MEMORANDUM

DATE: September 15, 2005
TO: Ken Petruzzelli
FROM: Tami Thompson, PE, MBK Engineers
SUBJECT: Linkside Place Inspection, ACL Order review

Figure 7

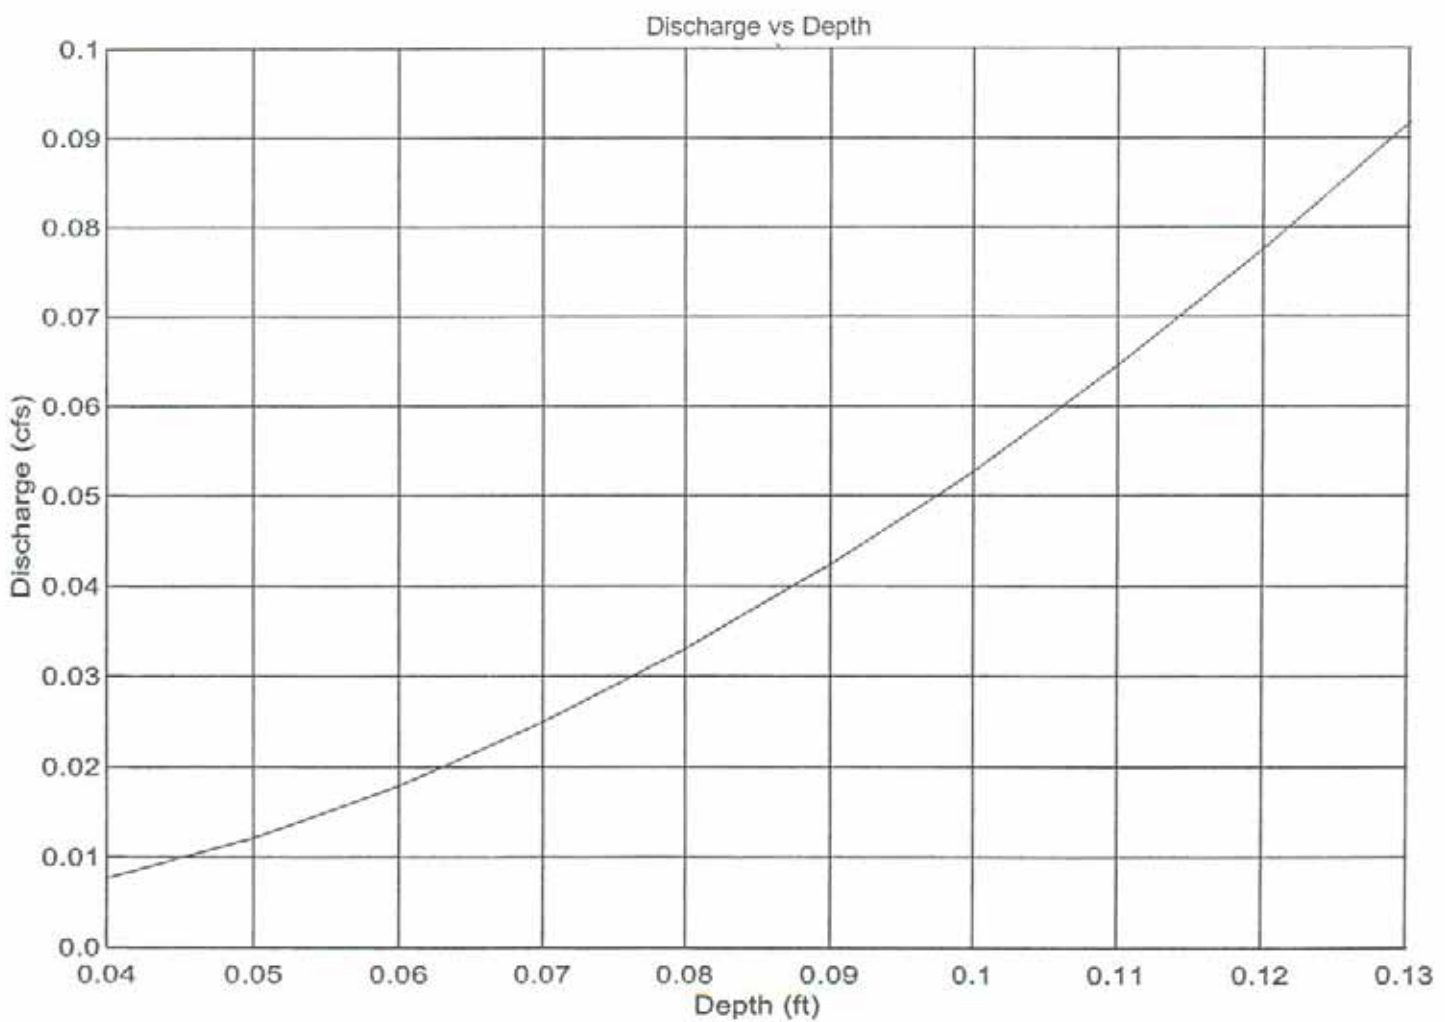
- o There is no indication on how the "Water depth" values were determined, and depth has a significant effect on discharge. If the depth of flow in the South culvert was 1.2 inches instead of the reported 1.5 inches the discharge would have been calculated at 0.05 cfs. Figure 7 plots discharge versus depth for the South culvert, figure 8 shows discharge versus depth for the North culvert (both figures used n=0.025).

Figure 9

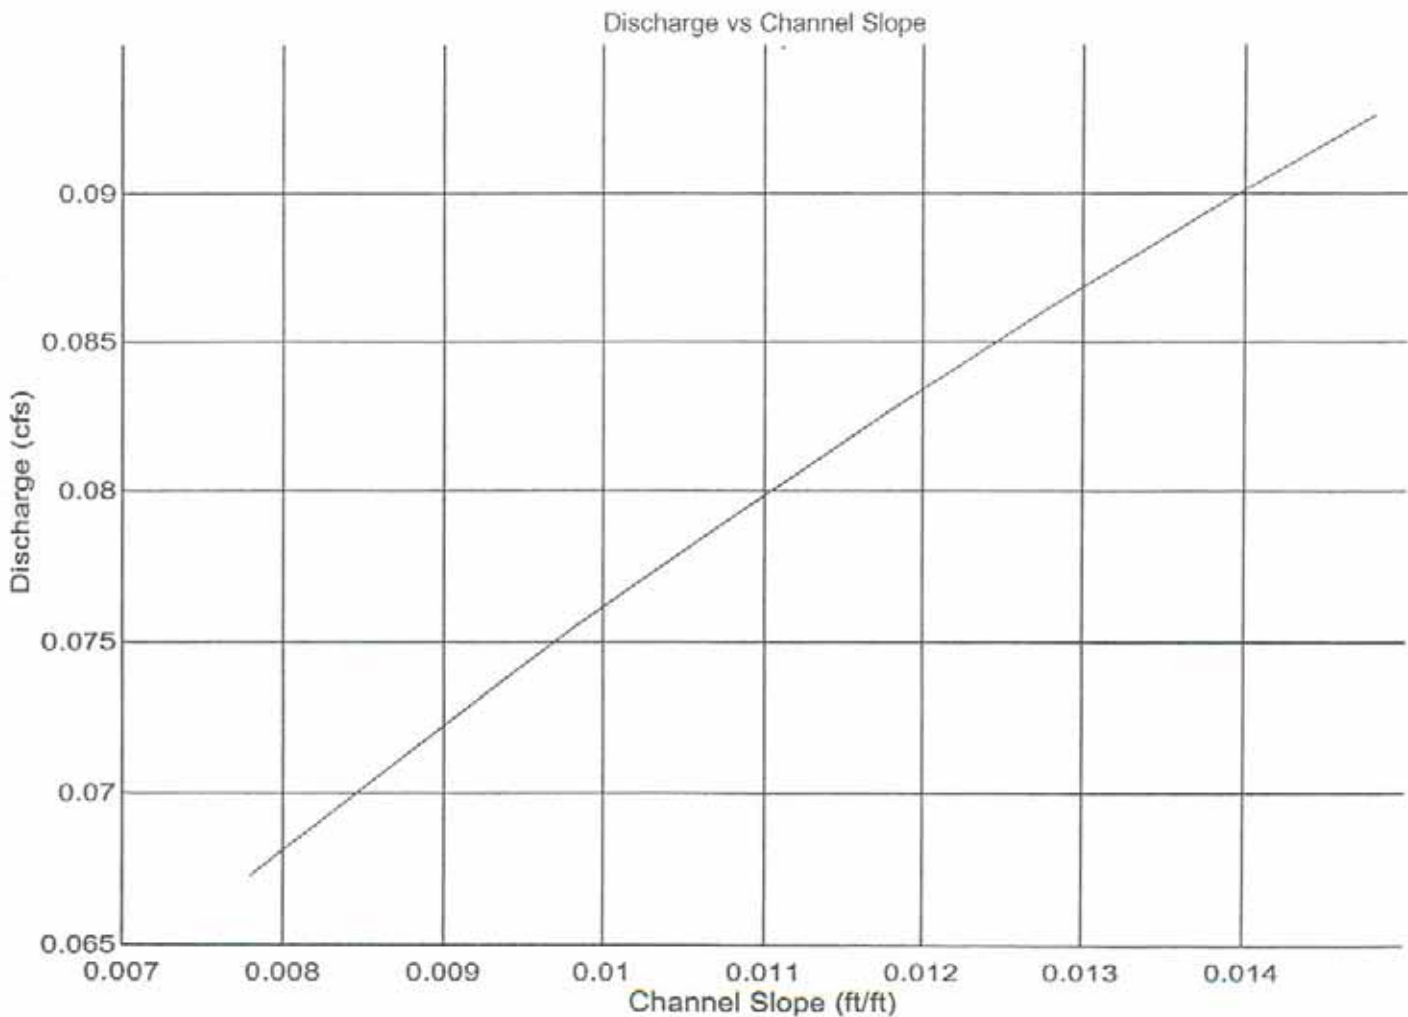
- o There is no indication on how the "Pipe Slope" values were determined. Discharge is proportional to the square root of the slope (as the slope decreases, the discharge decreases). The reported slope for the North culvert was 0.0078 feet/foot, over a 20 foot culvert this would be a change in elevation of 1.9 inches. The reported slope for the South culvert was 0.0145 feet/foot, over a 20 foot culvert this would be a change in elevation of 3.5 inches. Just looking at the photos, it is impossible to tell if these slope values are accurate, but if the south culvert was the same slope as the North culvert, the calculated discharge would have been significantly less. Figure 9 plots discharge versus slope for the South culvert with the originally reported 1.5 inch water depth (with the proposed 0.025 Manning's n-value). Figure 10 plots discharge versus slope for the South culvert with a water depth of 1.2 inches (n= 0.025). If the water depth was 1.2 inches and the slope was 0.0145 feet/foot, the discharge from the South culvert would have been 0.039 cfs for a total of 2625 gallons on February 25.
